Access Compliance Report

Public Rights-of-Way

Intersection ID: 13590	Main Street: CAMDEN_RD	Cross Street: TRYON_ST	Location: SE
ADA ID: 633C48E968C4	Ramp Type: Perp	Initial Pass/Fail: Fail	Overall Compliance: No
		Severity Score: 25

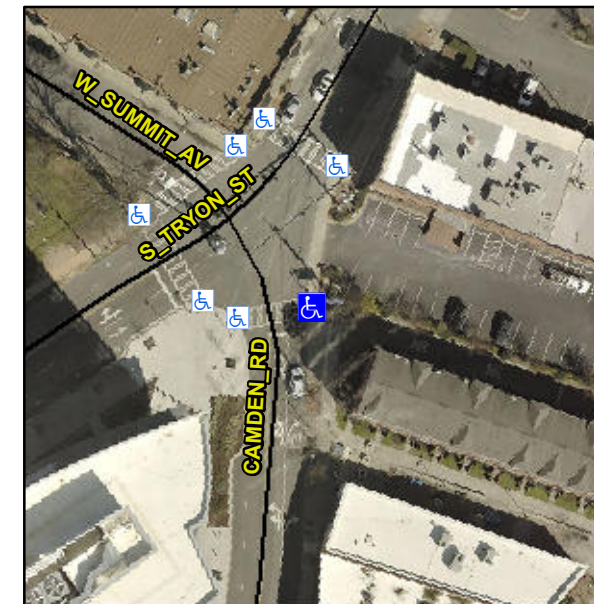
Not Found, R304.2.2, R304.5.3

Compliance	Description	Data	Compliance	Description	Data
N/A	Ramp Length (in)	27.0	No	Ramp Slope (%)	10.6
Yes	Ramp Width (in)	48.0	No	Ramp XSlope (%)	5.4
N/A	Flare Type LT	N/A	N/A	Flare Type RT	N/A
N/A	Flare Slope LT (%)	N/A	N/A	Flare Slope RT (%)	N/A
N/A	Flare Traversable LT?	N/A	N/A	Flare Traversable RT?	N/A
N/A	Landing Length (in)	N/A	N/A	DWS Provided?	N/A
N/A	Landing Width (in)	N/A	N/A	DWS Contrast?	N/A
N/A	Landing Slope (%)	N/A	N/A	DWS Length (in)	N/A
N/A	Landing X Slope (%)	N/A	N/A	DWS Full Width?	N/A
N/A	Landing Curb? (Y/N)	N/A	N/A	DWS Offset (in)	N/A
N/A	Shared Landing?	N/A			
N/A	Gutter Ponding?	N/A	N/A	Gutter Slope (%)	N/A
N/A	Gutter Lip Ht (in)	N/A	N/A	Gutter X Slope (%)	N/A
N/A	Painted X Walk1?	Yes	N/A	Painted X Walk2?	N/A
	X Walk 1 Direction	To W		X Walk 2 Direction	N/A
N/A	X Walk 1 Width (in)	99.0	N/A	X Walk 2 Width (in)	N/A
	X Walk 1 Slope (%)	4.2		X Walk 2 Slope (%)	N/A
	X Walk 1 X Slope (%)	1.6		X Walk 2 X Slope (%)	N/A

Remove & Replace Entire Ramp.
